Portland General Electric Company

June 25, 1979

Trojan Nuclear Plant
Docket 50-344
license NPF-1

EMERGENCY INSTRUCTION EI-1
LOSS OF REACTOR COOLANT

Figure 3.2
RCS PRESSURE (psig)

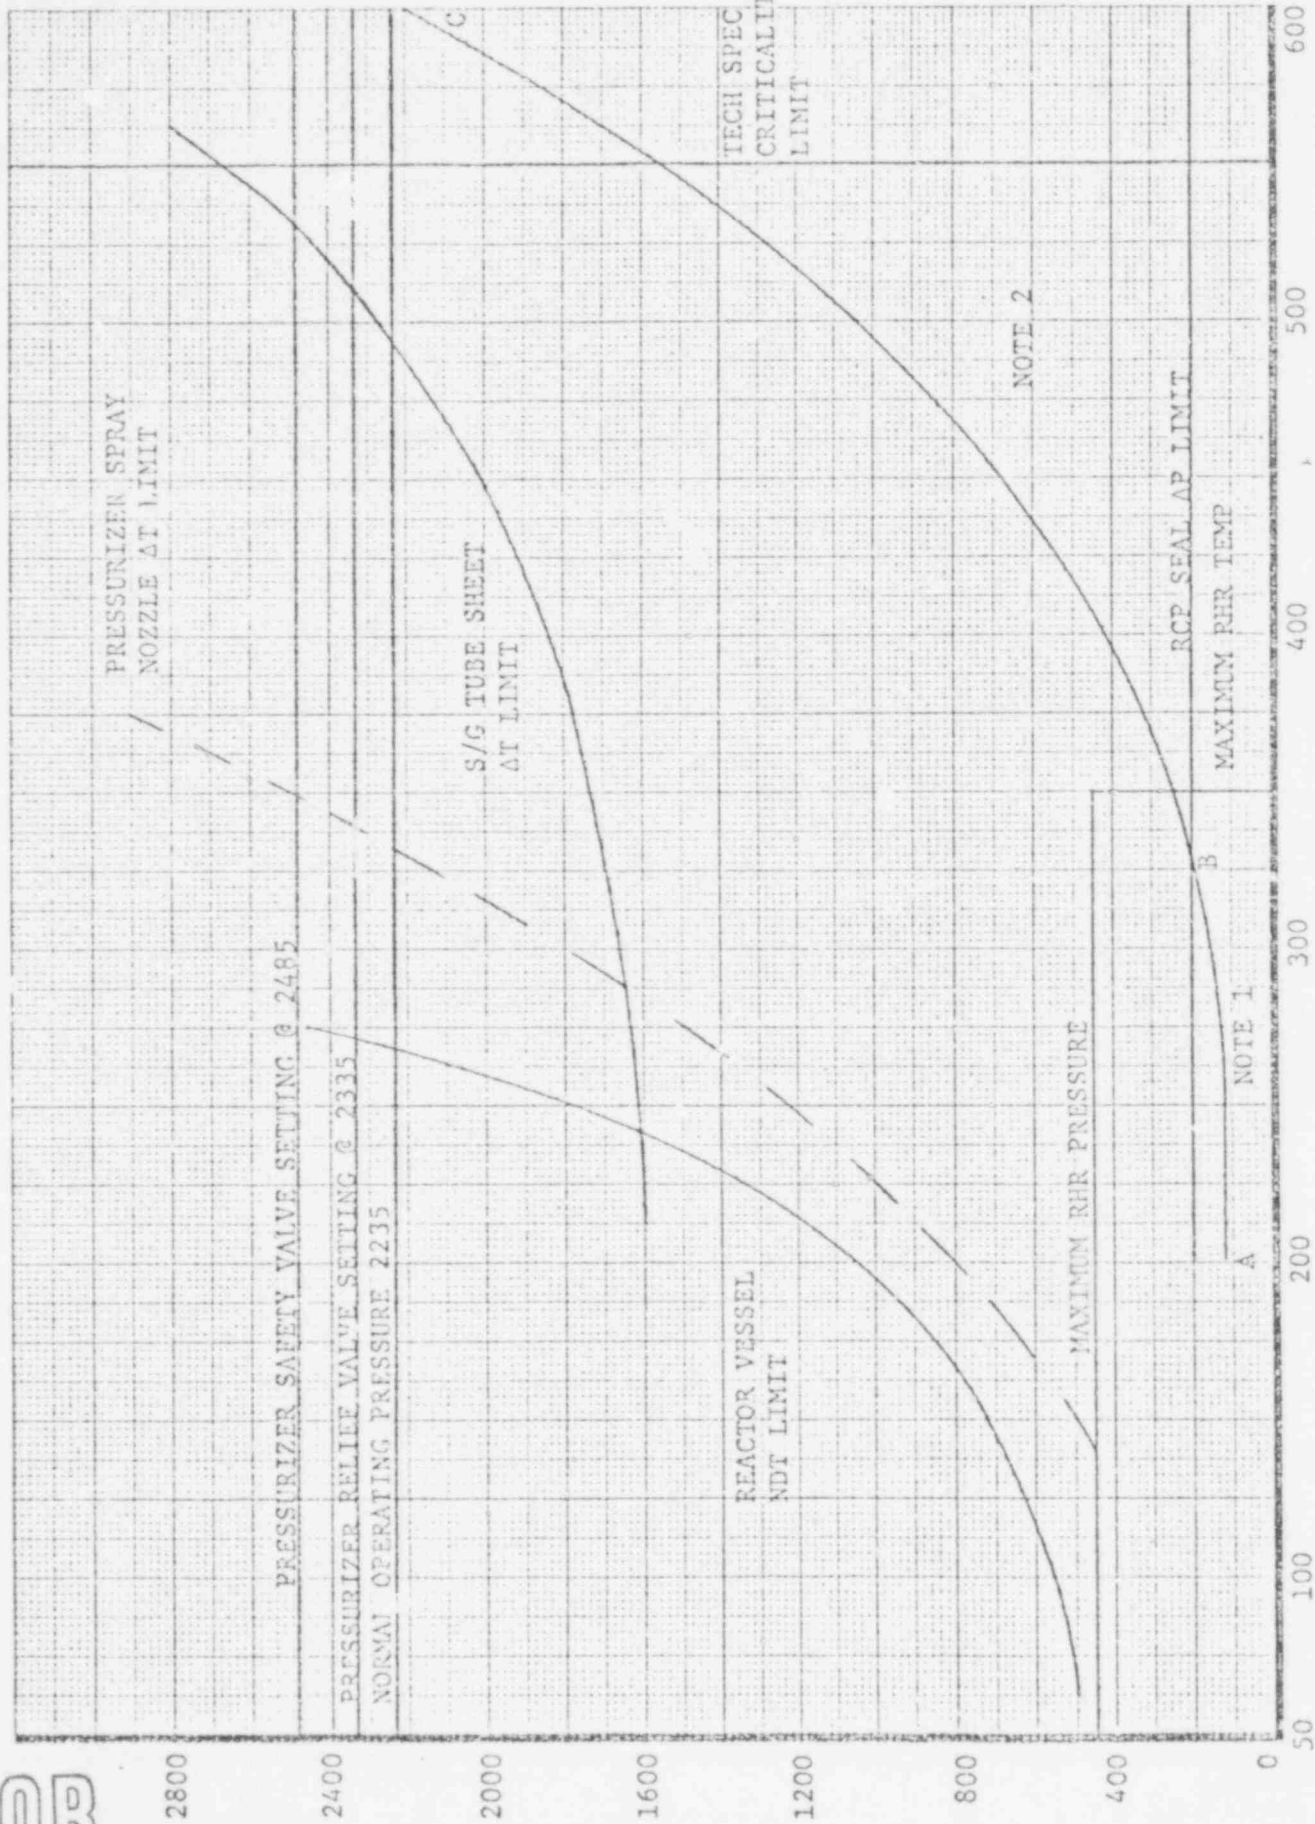
"B. Maintaining pressurizer level alone may not prevent excessive boiling in the RCS and resultant voids that may compromise the core cooling capability and natural circulation. Keeping pressure within the limits of the pressure temperature curves of Figure 3.2 of the CROCTRM [Control Room Operating Curves and Tables Reference Manual] ensures that saturation is not reached."

Figure 3.2 referred to in the "CAUTION" statement has been revised to ensure that 50 degrees sub-cooling is maintained, per the requirements of Bulletin 79-06A (see Attachment 2). Furthermore, we are preparing a procedure which provides a backup means of indication for some primary Plant parameters for long-term monitoring. Attachment 3 is a list of backup means of indication and will be a part of the new procedure. The discussion associated with pressurizer level describes Plant parameter behavior under voiding conditions. This procedure, which will be in effect by June 30, 1979, along with Figure 3.2, will be valuable aids to the operator to guide him in maintaining safe Plant conditions at all times, including adverse conditions.
